# Inner Walled City

### Options Report

Options report relating to issues raised by Royal National Institute of Blind People, the Guide Dogs for the Blind Association, IMTAC and Disability Action.

## Proposed Parking Provision & Kerb Upstand

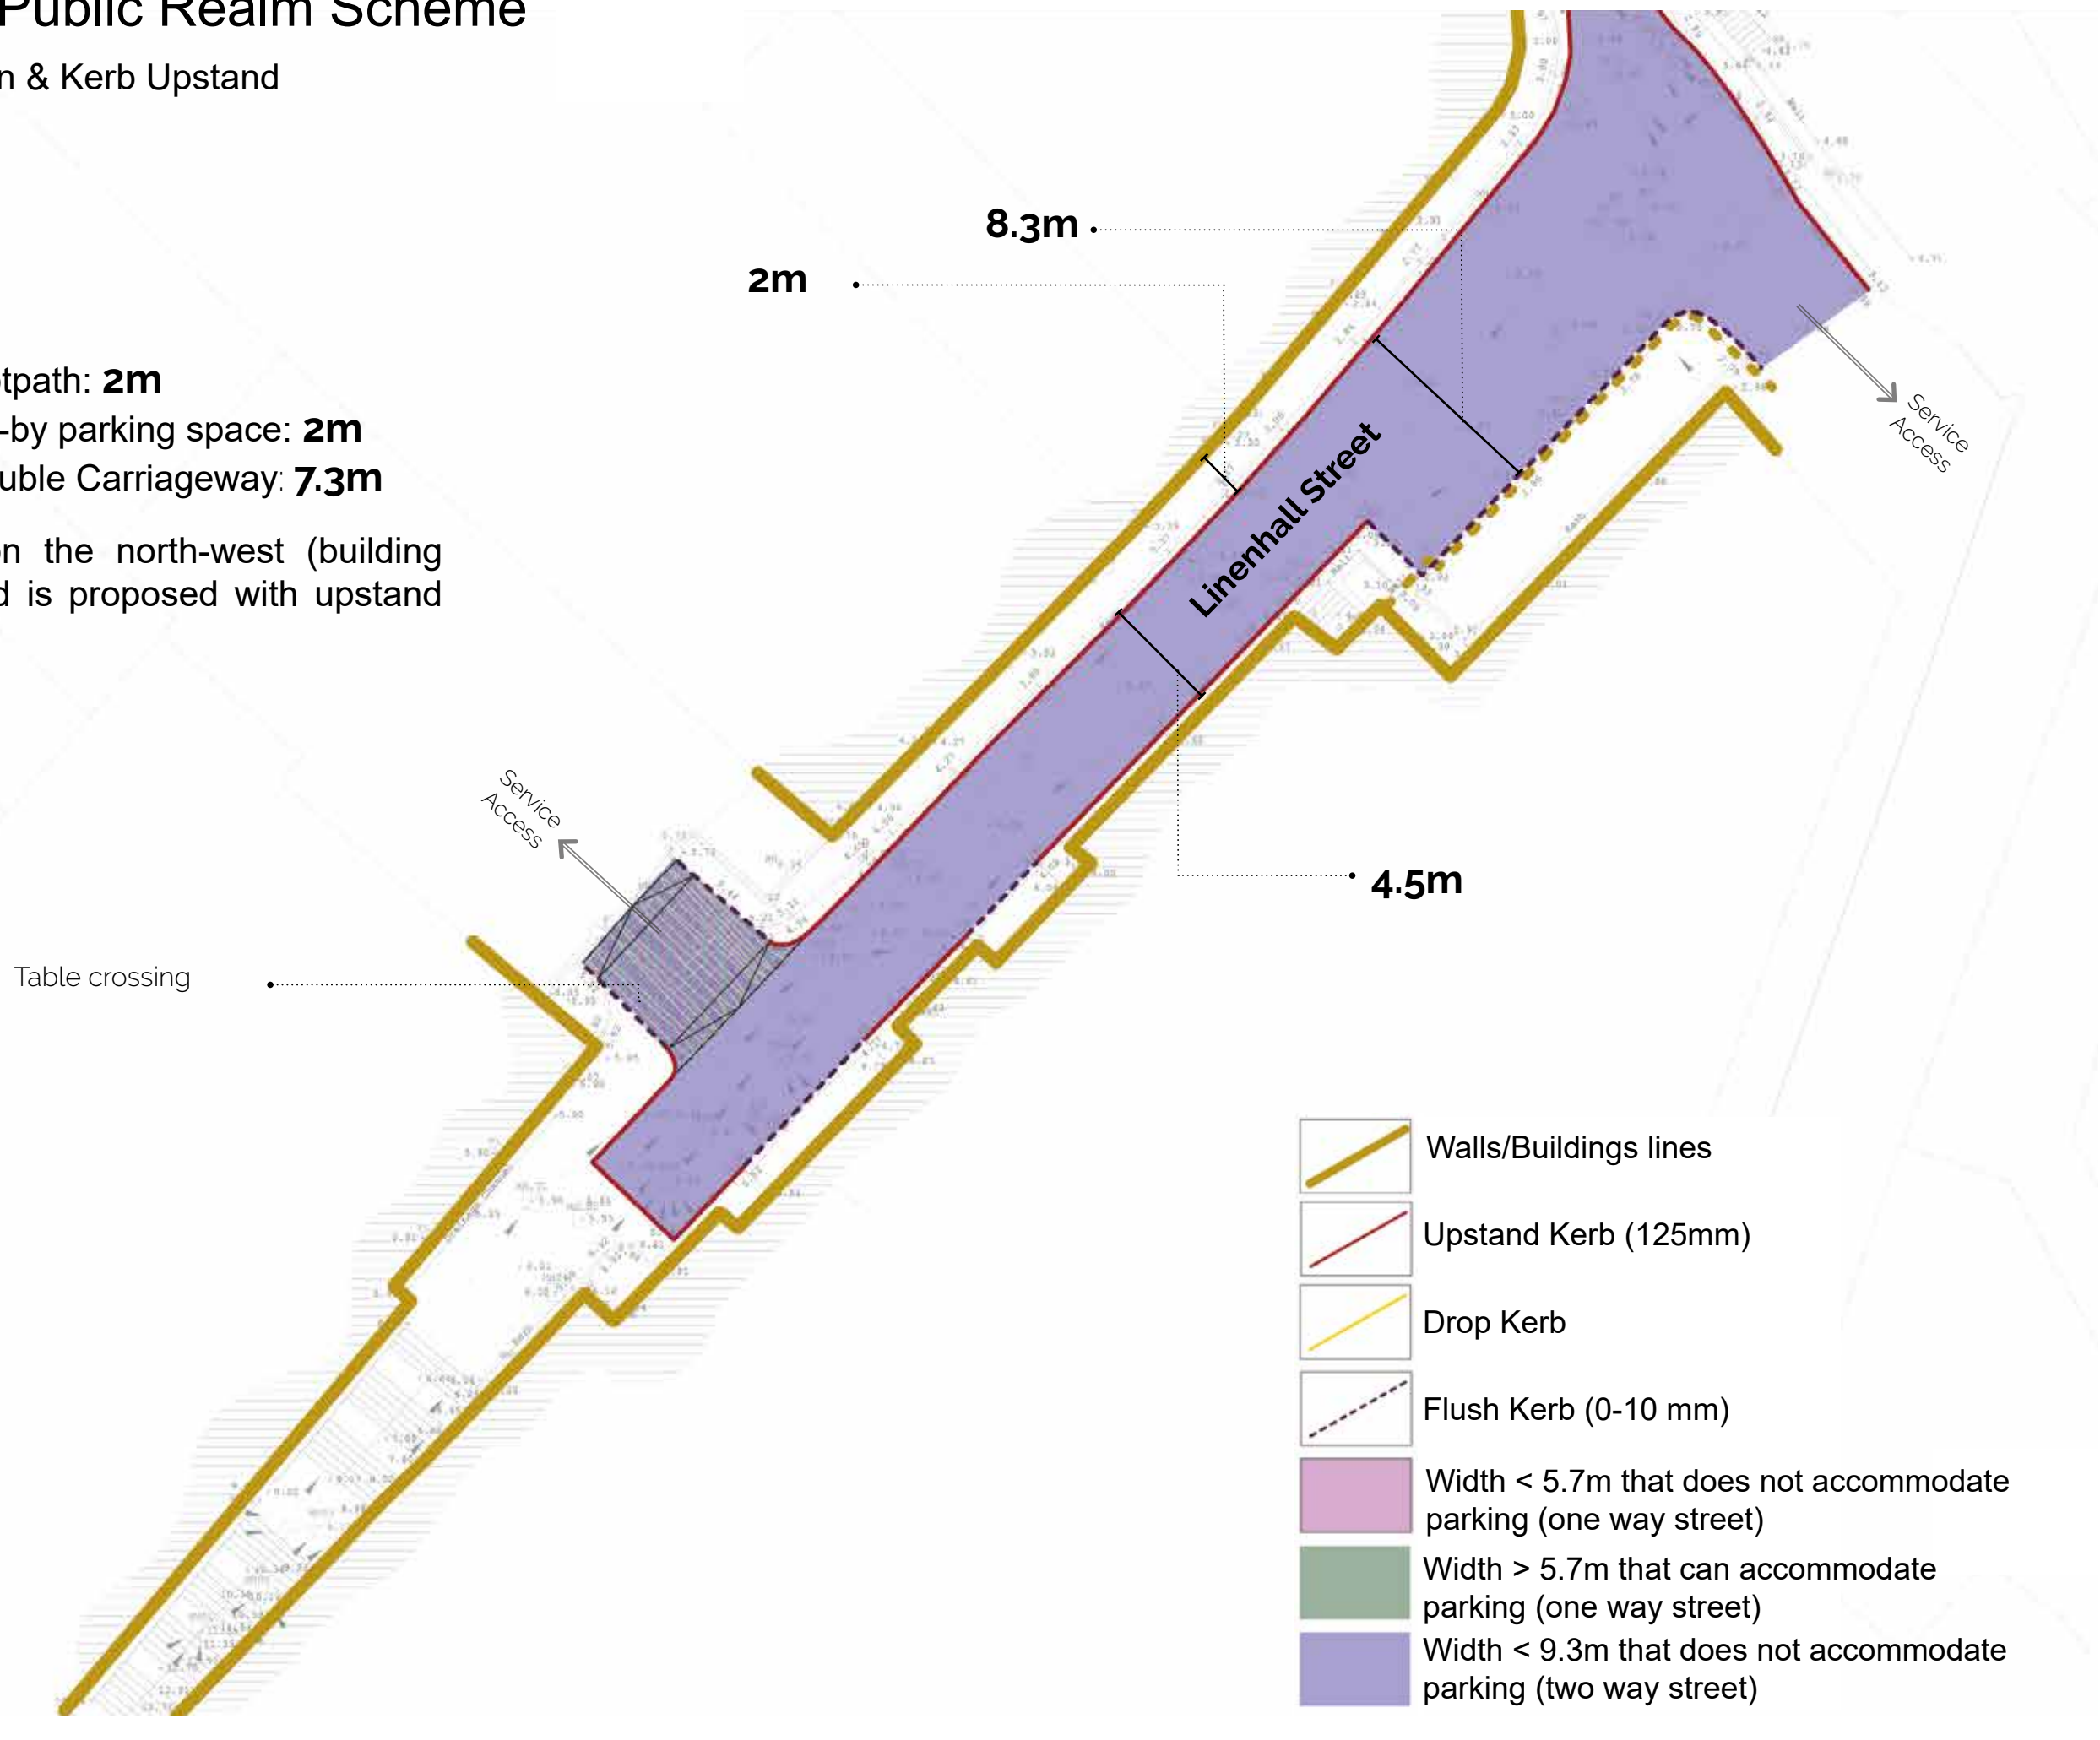
A **2 m** wide footpath on the north-west (building frontage) side of the road is proposed with upstand kerb (125mm).

Scale 1:250  
Sheet 2 of 8

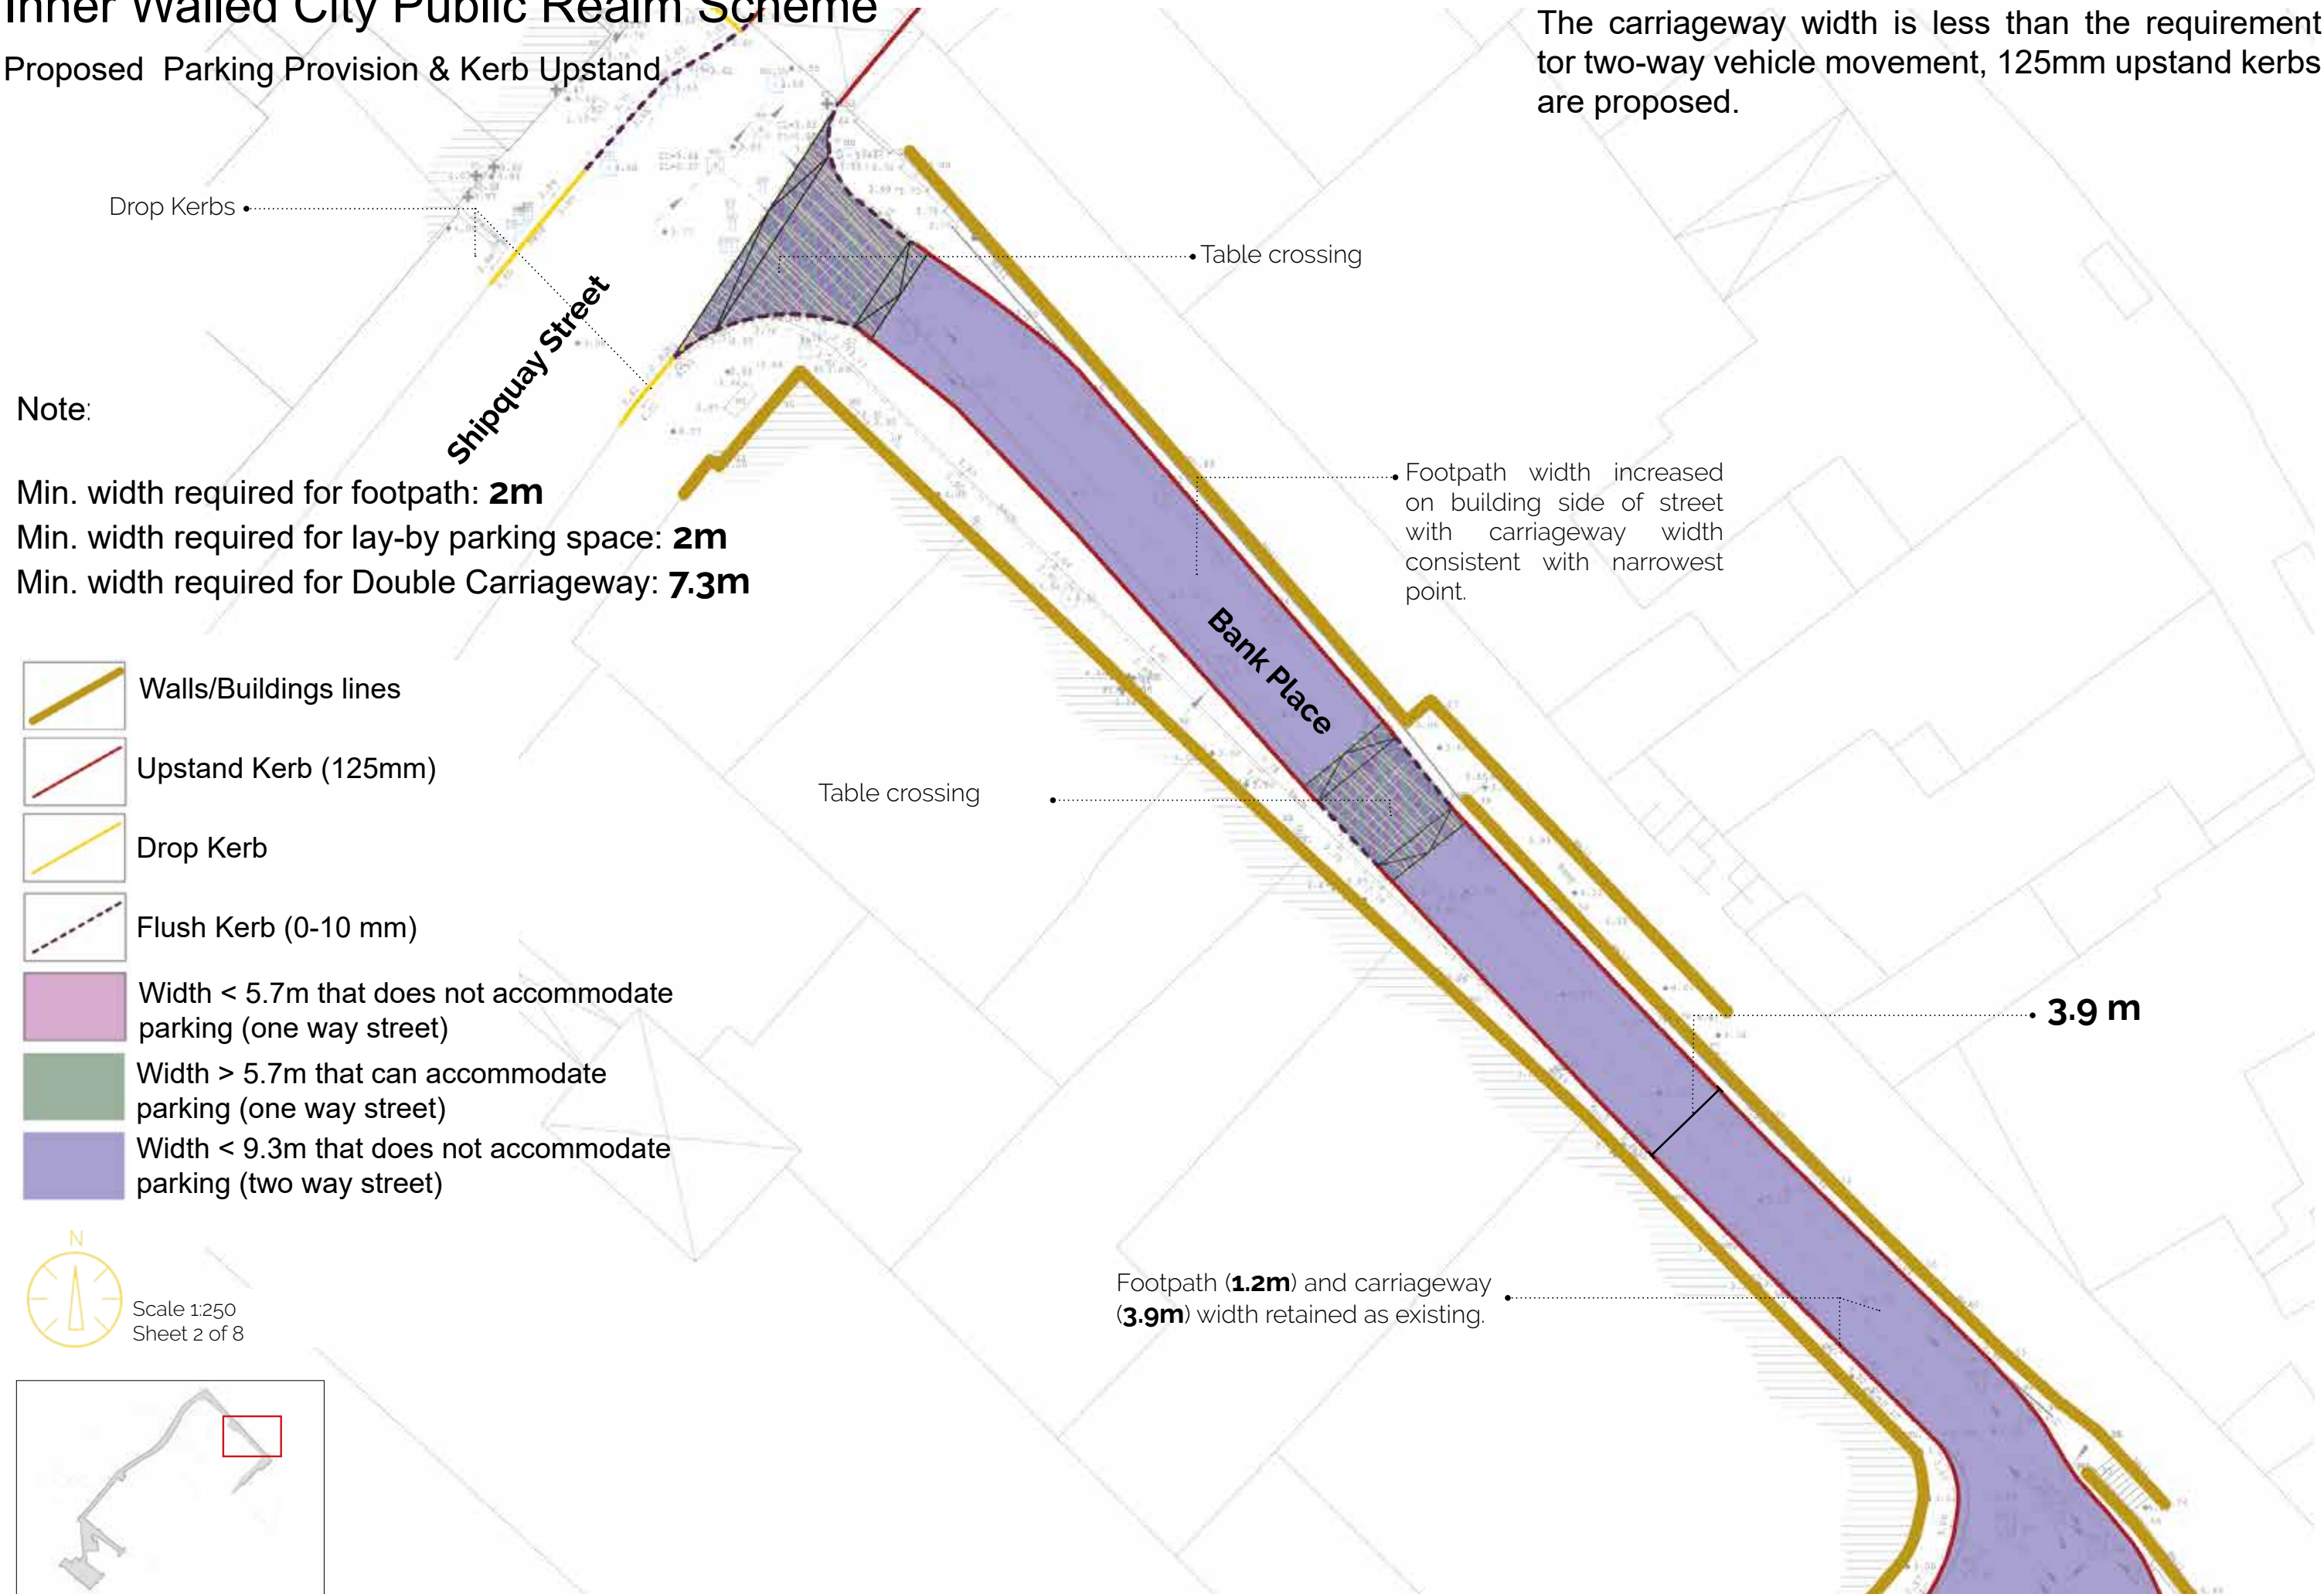
The carriageway width is less than the requirement for two-way vehicle movement, 125mm upstand kerbs are proposed.

## Proposed Parking Provision & Kerb Upstand

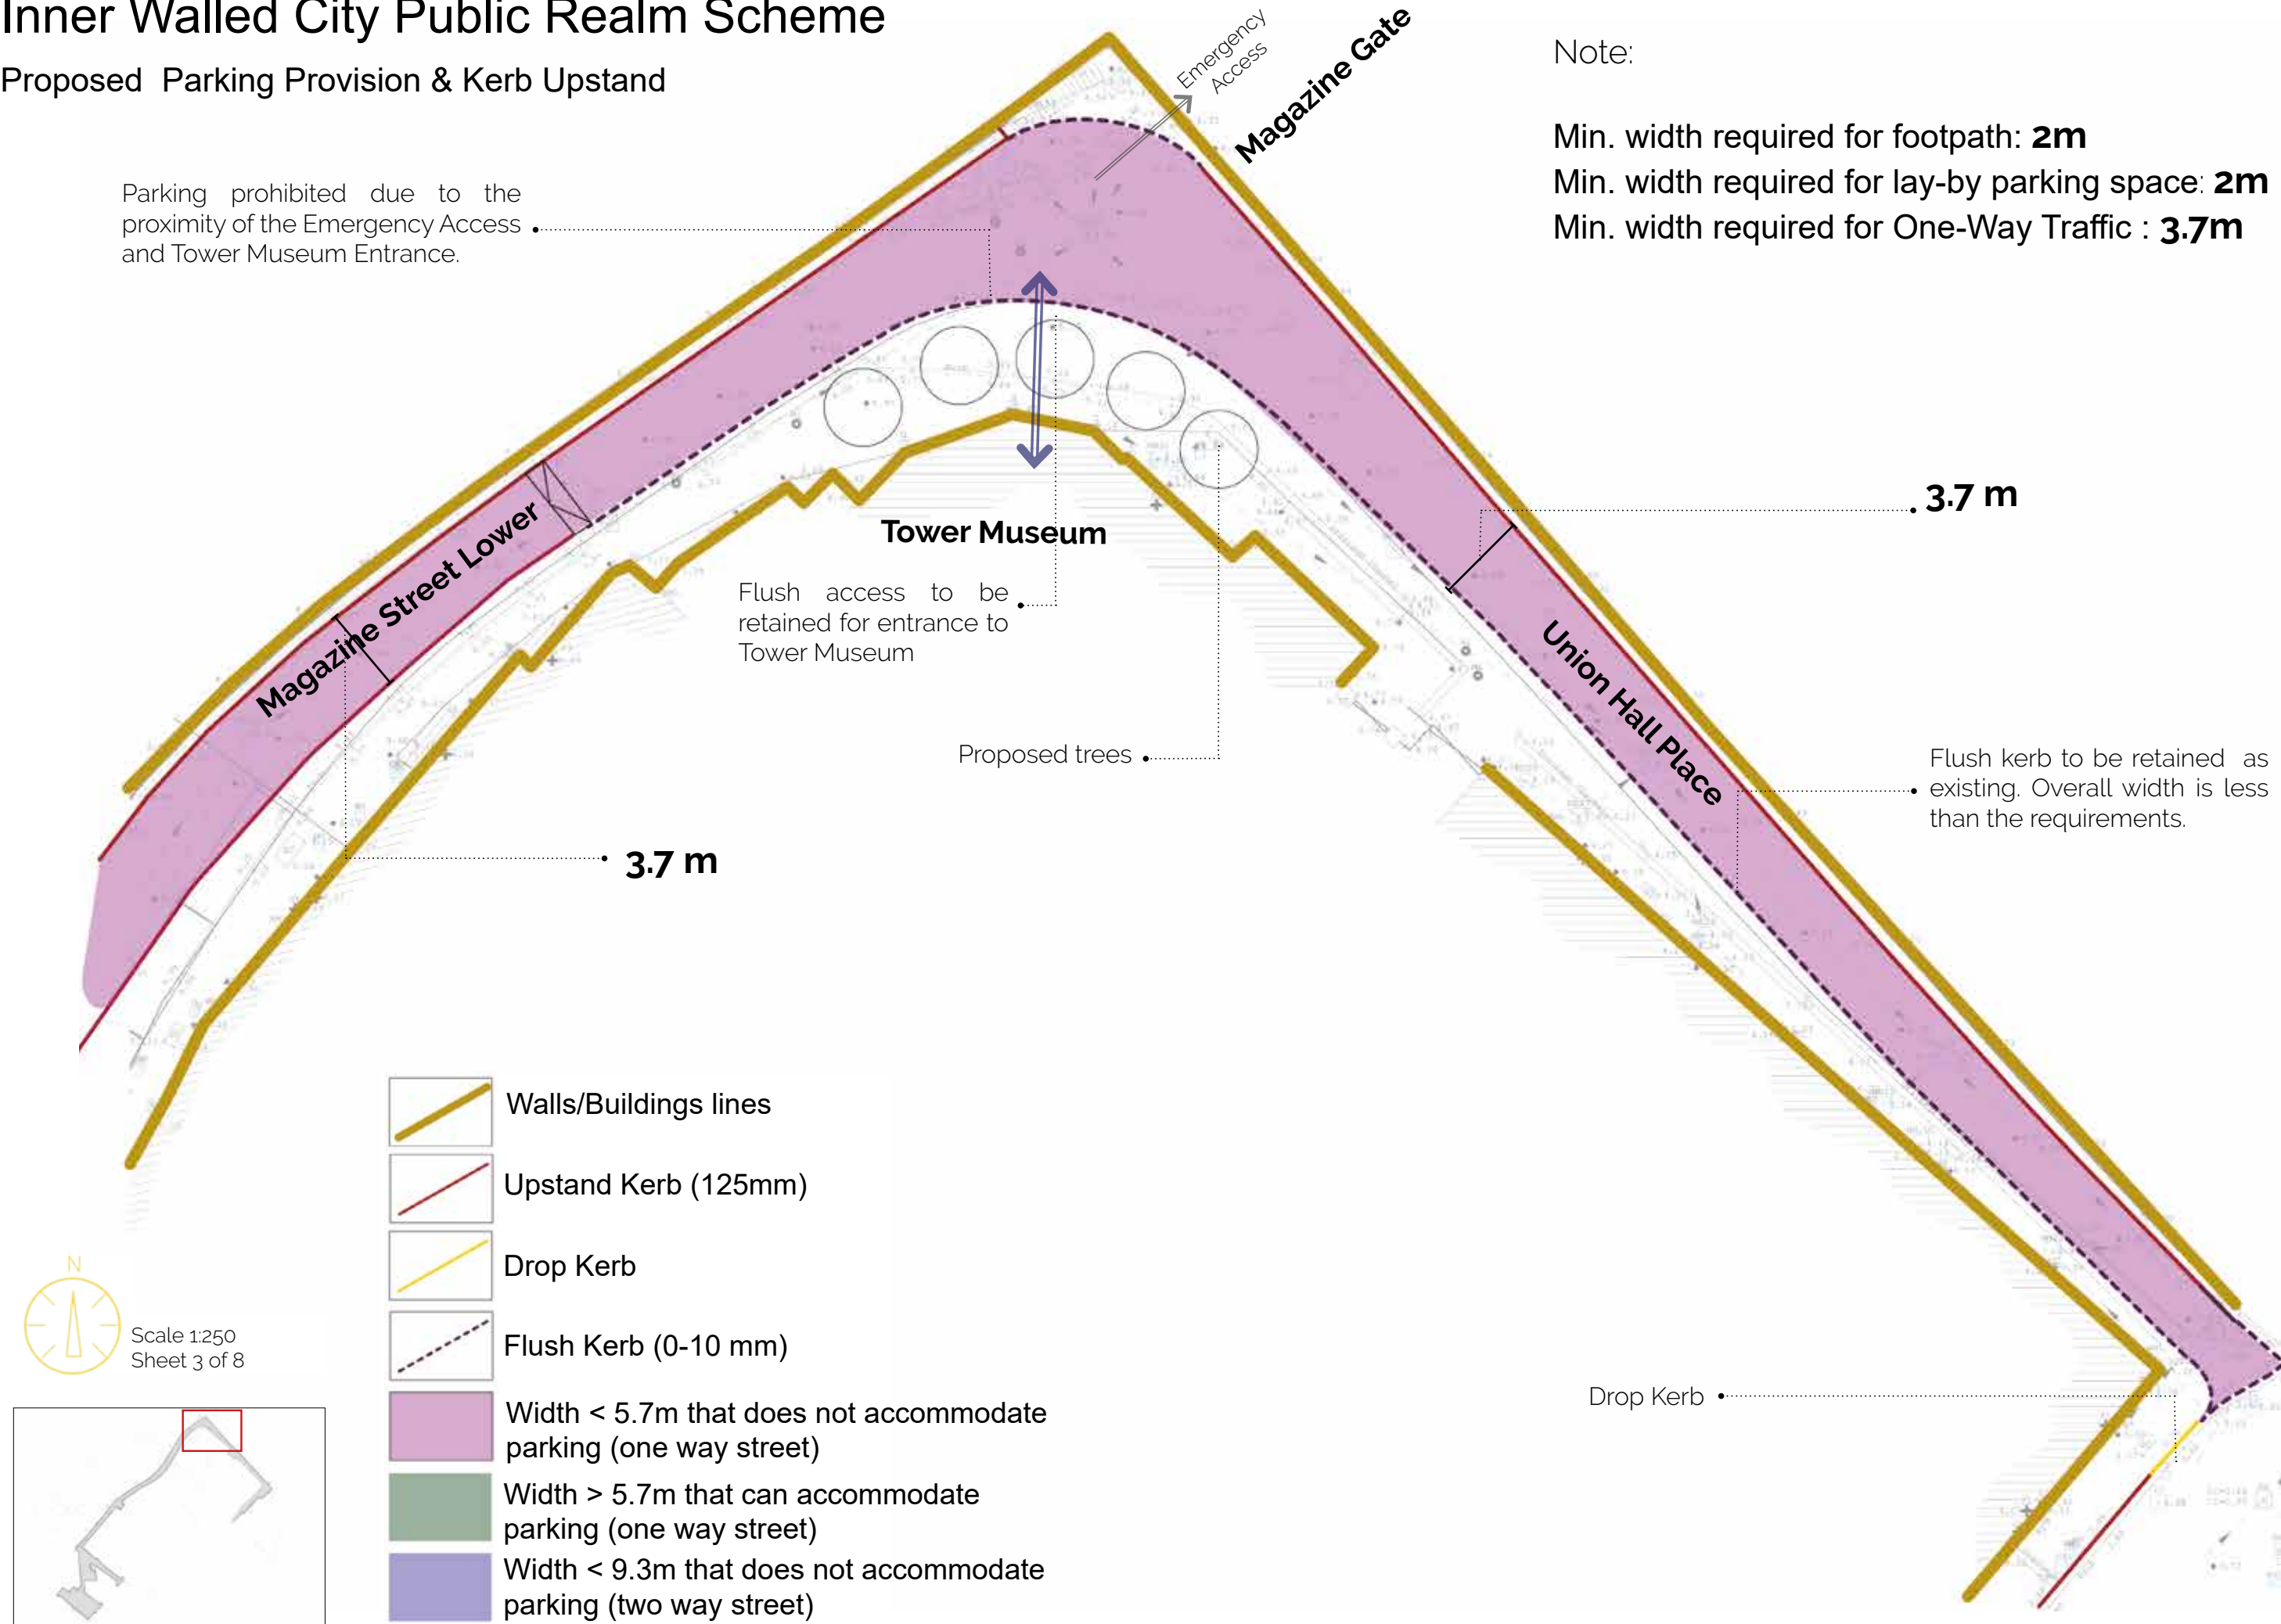
Parking prohibited due to the proximity of the Emergency Access and Tower Museum Entrance.
